# 21154 PCI-to-PCI Bridge

## Specification Update

*July 2004*

Order Number: [278295-017](#)

Figure 1. S\_Clock Multiplexer Workaround Circuit for Errata 6.

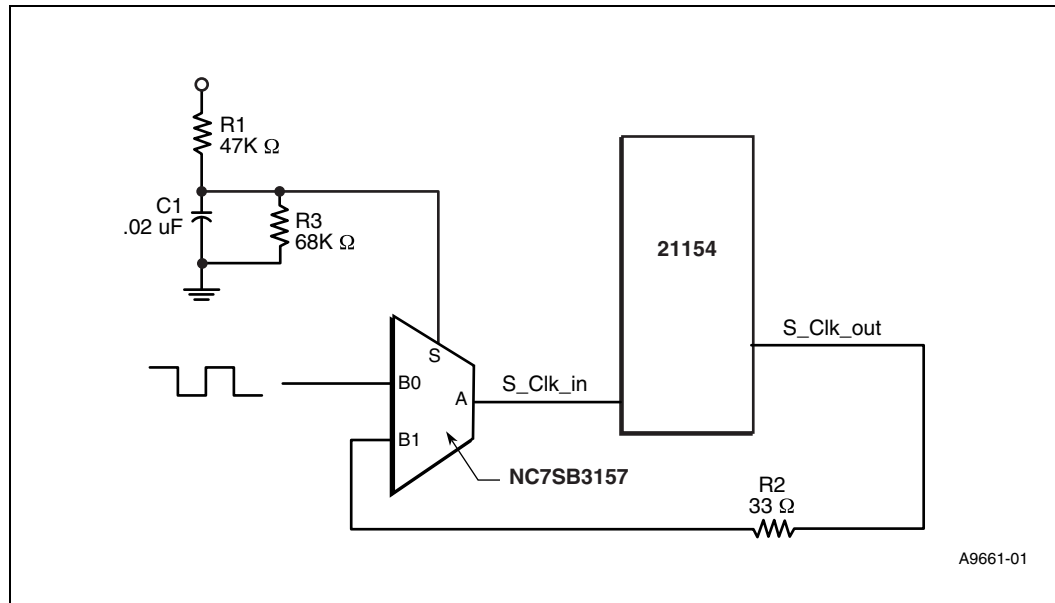
## 6. Secondary Clocks Outputs s\_clk\_o<9:0> May Not Start-up Properly Under Some Conditions

**Problem:** This problem has been found on the 21154AC and 21154BC. Under repeated and frequent power cycling, the secondary clock circuits may not power up in the proper state, resulting in the device not coming out of reset after power up.

**Implication:** In a system with a 21154AC or 21154BC that has one of its s\_clk\_o<9:0> outputs fed back to provide the s\_clk, it is possible that the s\_clk\_o<9:0> output clocks will be driven and remain low, keeping s\_rst\_l asserted, during system power up.

1. [Figure 1](#) illustrates the first recommendation - a circuit where an on-board pulse source is gated via the B0 input of the multiplexer to the S\_Clock\_in pin of the 21150.

At time 0, the S input of the multiplexer is low, allowing pulses from the on-board pulse source, connected to the B0 input, to be provided to the 21150 S\_Clk input pin. When the time determined by the R/C network is satisfied, the S input pin will be in a logic High state. The multiplexer will then shut off the input pulse from S0 and will direct the S\_Clock\_out pulses via the B1 multiplexer input, into S\_Clock\_in

The values used for the R/C network should be selected to allow a minimum of 2 pulses to be delivered to the 21150 after Vdd has reached 3.0V at a frequency not to exceed the appropriate PCI component. i.e. 30 ns for a 33Mhz bridge. These values should be chosen based on the rise time of the power supply and the frequency of the on board pulse source. The values given for R1, R3, and C1 are for example purposes only.

**Note:** The NC7SB3157 2:1 Multiplexer / Demultiplexer Bus Switch used in this example has a maximum propagation delay of 800ps that should be taken into consideration when matching trace lengths of the clock lines to avoid introducing excessive skew in the clocks. All S\_Clock etch lengths must be matched to within 2ns @ 33Mhz or 1ns @ 66Mhz. The addition of this circuit requires that the etch length for the S\_clock\_in signal be reduced to compensate for the 800ps delay.

Figure 2. Recommended Circuit for a Tristable Buffer

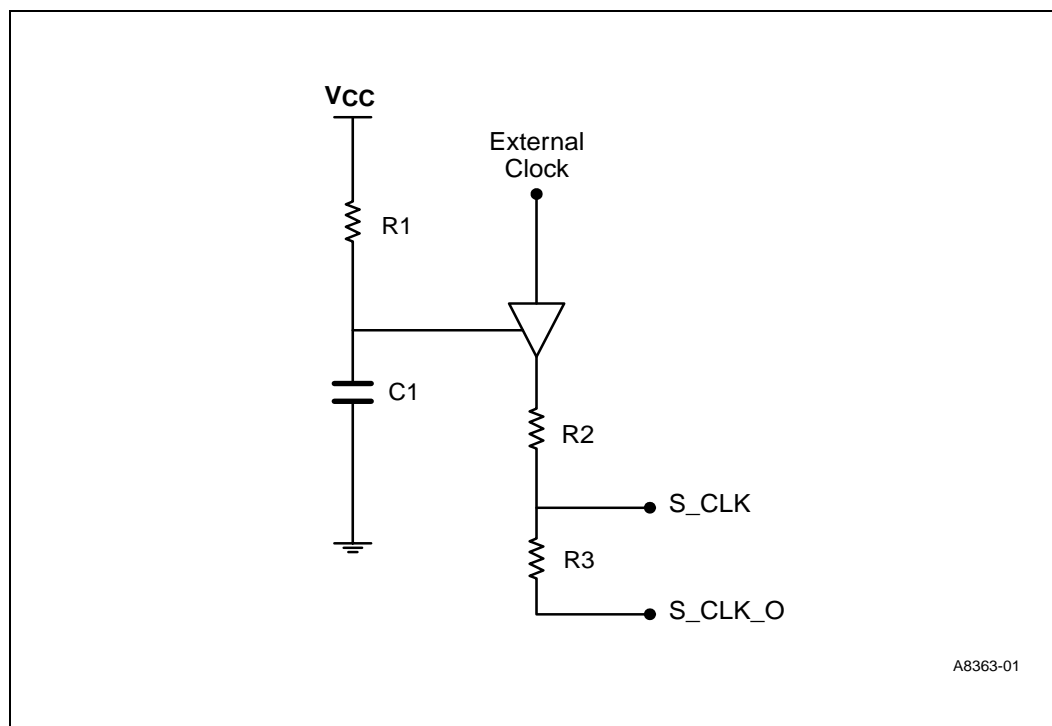
2. In the second recommendation, to guarantee the proper initialization of the **s\_clk** circuits, the addition of an external circuit that provides a minimum of two transitions on the **s\_clk** input during the power-up ramp is necessary. This can be done using a solution that drives an external clock onto the **s\_clk** input while 3.3V Vcc is ramping during power up.

Figure 2 illustrates the use of a tristable buffer to provide multiple pulses to the **s\_clk** input. The Vcc ramp rate and R1,C1 time constant determine the duration and amplitude of the pulses generated during power up. The R2-R3 values are chosen based on applicable board etch impedance-matching requirements.

The following should be considered in calculating the R1,C1 time constant:

- Make the time constant of the circuit as short as possible, while still ensuring that a minimum of two pulses are generated during the Vcc ramp.
- Phase delay between **s\_clk\_o** and the external clock should be minimized.
- Matching the external clock and **s\_clk\_o** frequencies to reduce contention.
- Laboratory experiments using **p\_clk** as the external clock and a R1C1 time constant between 40 and 60 percent of the Vcc ramp have been successful using this configuration. However the use of **p\_clk** as the external clock violates the PCI bus specification for loading of the primary clock.

**Figure 6. Removal of Pull-Down Resistor for JTAG Testing**

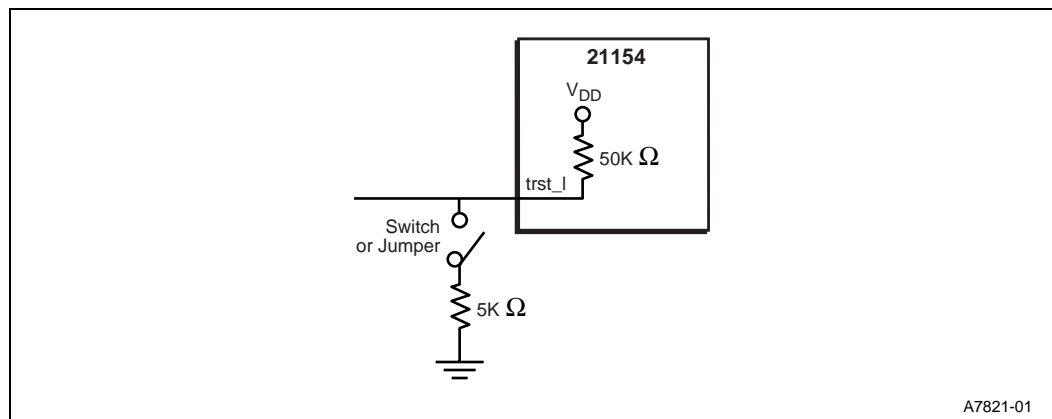
**9. Section 6.3.1, Signal trst\_l Pull-Down Resistor, New Section**

The following new section has been added:

A 5 K  $\Omega$  pull-down resistor is required on trst\_l for normal PCI-to-PCI bridge operation. However, some JTAG test results may be inconclusive if the 5 K  $\Omega$  resistor remains in the circuit. To obtain accurate JTAG results, Intel recommends one of the following solutions:

- Verify that the JTAG test equipment, after driving trst\_l low to reset the TAP controller, constantly drives trst\_l high during JTAG tests. If this signal is not constantly driven high, the 5 K  $\Omega$  resistor will pull the signal to a low state.
- Remove the 5 K  $\Omega$  resistor during JTAG tests. This resistor must be installed during normal PCI-to-PCI bridge operation.
- Design external circuits with a switch or jumper to isolate the 5 K  $\Omega$  resistor during JTAG tests (see Figure 6). This switch must enable the resistor during normal PCI-to-PCI bridge operation.

**Figure 19 Example of GPIO Clock Mask Implementation on the System Board**

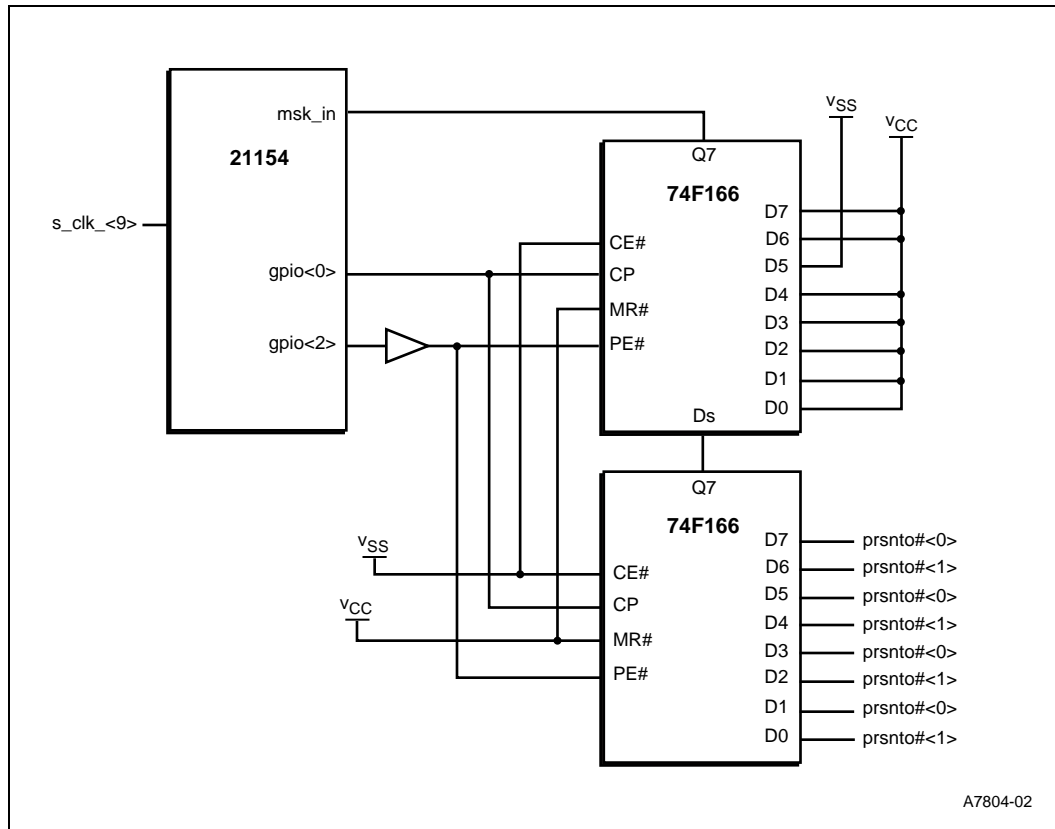
**12. Section 10.2, Secondary Clock Control, Figure 19**

This figure now appears as follows:

**Figure 20. Clock Mask and Load Shift Timing**

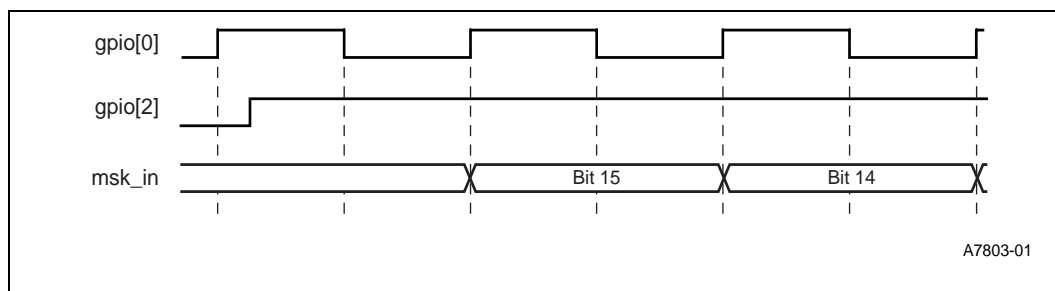
**13. Section 10.2, Secondary Clock Control, Figure 20**

This figure now appears as follows:

**Figure 21. Clock Mask and Load Shift Timing**

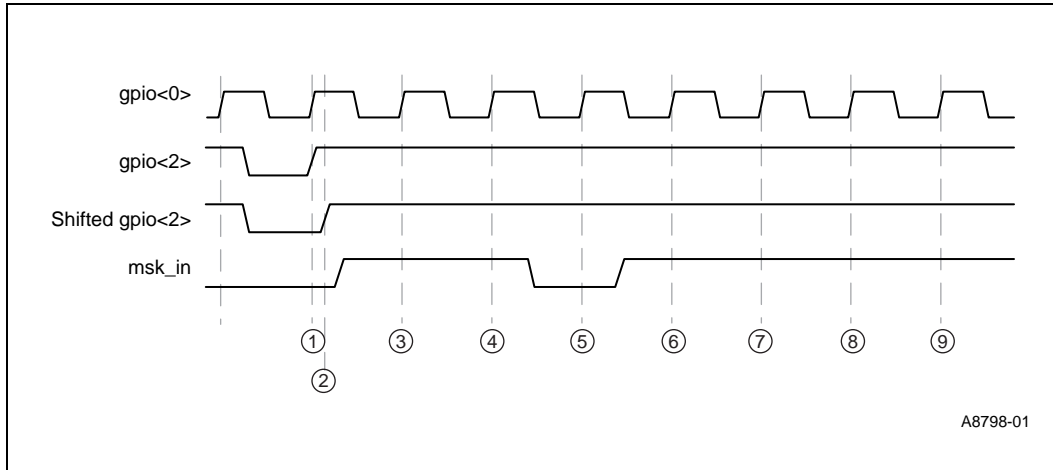
**15. Section 10.2.1, Mask and Load Shift Timing Events for 66 MHz Operation**

The following new section has been added:

The following list provides the timing sequence for 66 MHz operation for an example circuit as shown in [Figure 19](#) and the timing diagram in [Figure 21](#).

1. The **gpio<2>** original coming from the 21154 does not provide 3ns setup time needed to provide the parallel load enable **PE#** of the 74F166.
2. The shifted **gpio<2>** is delayed by ~9ns to provide ample setup time to enable the parallel of the shift register connected to pin 15 of the 74F166.
3. Bit 15 input **D6** of the shift register is pulled high, to Vcc.
4. Bit 14 input **D7** is pulled high, to Vcc. These signals are not used internally in the 21154.
5. Bit **13 s\_clk\_o<9>** is a feedback to the 21154 **s\_clk\_o** input. To enable **s\_clk\_o<9>** in all cases the **D5** input of the shift register is grounded, to Vss.
6. Bit 12 **s\_clk\_o<8>** is disabled.
7. Bit 11 **s\_clk\_o<7>** is disabled.
8. Bit 10 **s\_clk\_o<6>** is disabled.
9. Bit 9 **s\_clk\_o<5>** is disabled.

**Figure 3 Example of GPIO Clock Mask Implementation on the System Board**

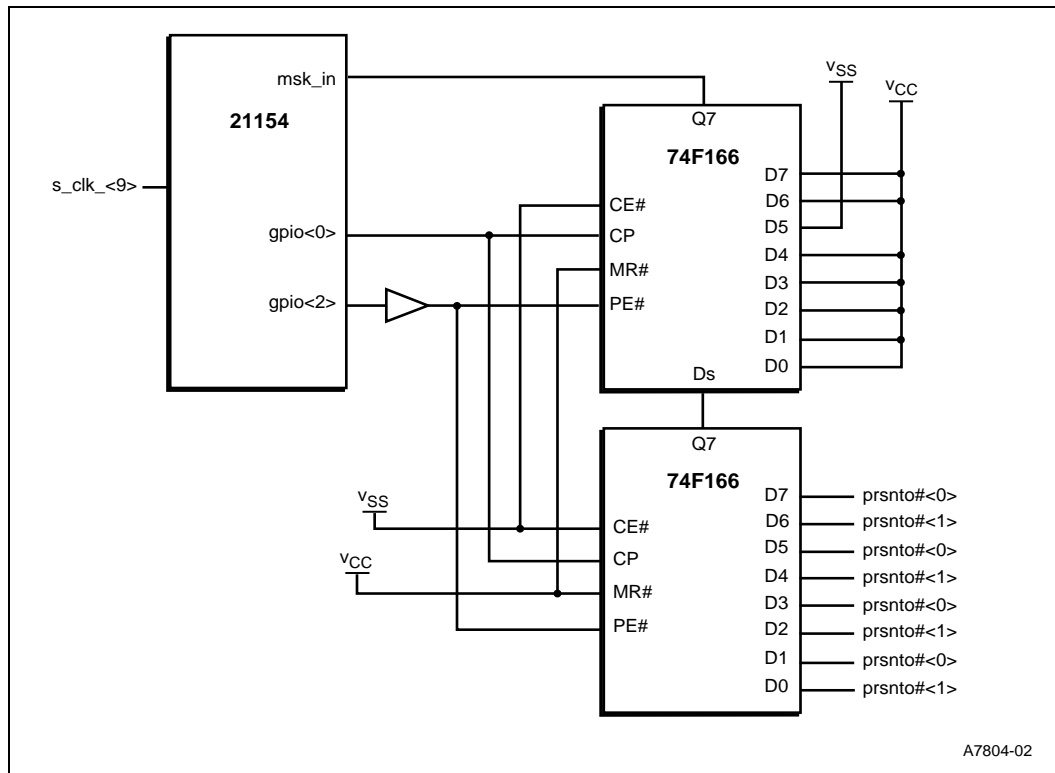
**18. Section 4.4.1, Serial Clock Mask Shift, Figure 3**

Figure 3 has been updated as follows:

**Figure 4. Clock Mask Load and Shift Timing**

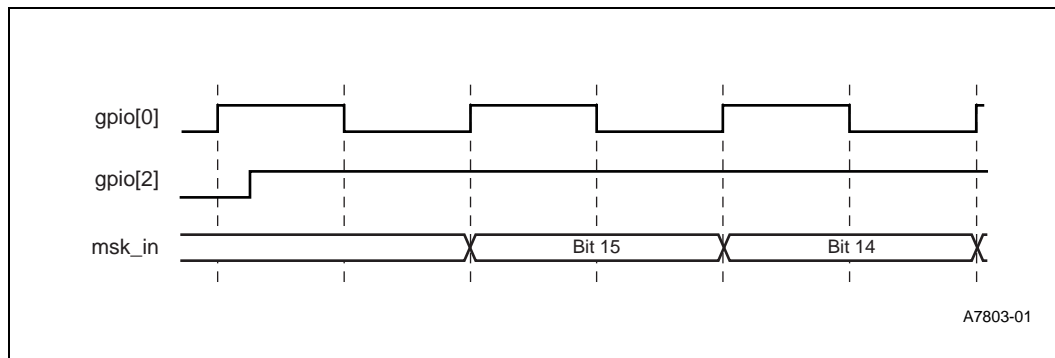
**19. Section 4.4.1, Serial Clock Mask Shift, Figure 4**

Figure 4 now appears as follows:
